1959 Corvette: Service Bulletin: Excessive Driveline Vibration

Source: General Motors of Canada Service Bulletin

Date: September 30, 1959

The propeller shaft and pinion angle and the elongation of the radius rod mounting bracket hole is shown in Fig. 44.

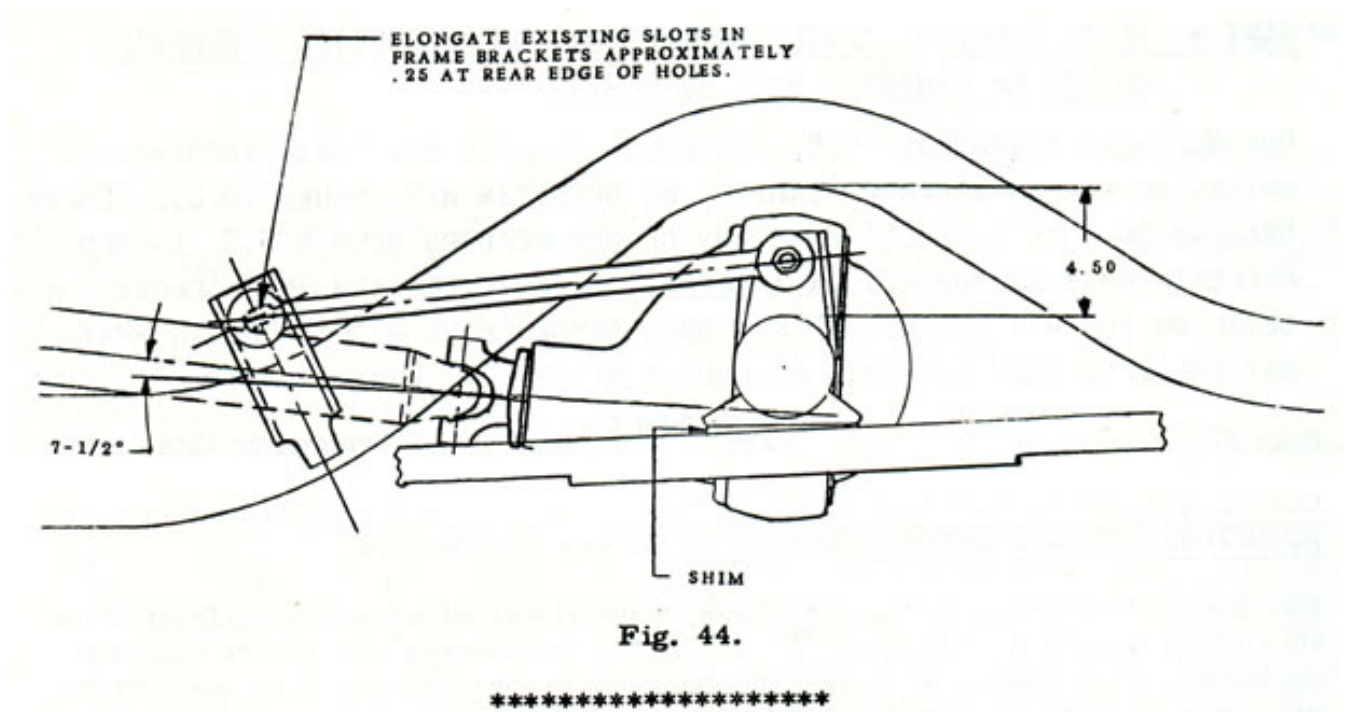
If excessive drive line vibration is encountered on the 1959 Corvette, it is probably due to excessive rear U-joint angle. Elimination of the vibration can be accomplished by installing either a 2° or 3° shim between the axle pads and springs on both sides, with the thick side to the front.

The nominal angle of the rear U-joint is 7-1/2°. Care should be taken in not going under 7-1/2° due to interference at full bump position.

1. Load vehicle until distance between the axle housing and the frame rail kick (metal to metal) is 4-1/2". Retaining the vehicle in this position, the angle of the propeller shaft and pinion nose can be measured, as shown in the 1958 Passenger Car Shop manual.

2. The radius control rods should be disconnected before installing the shim. Before re-attaching the radius control rods, elongate the radius rod frame mounting hole 1/4" rearward if necessary to eliminate any interference between the radius control rods attaching bolt and mounting bracket. Shim part #3722797 (2 °), or #3744488 (3 °), or their equivalent may be utilized. The locating tab on the above shims should be removed to allow the shim to lie flat.
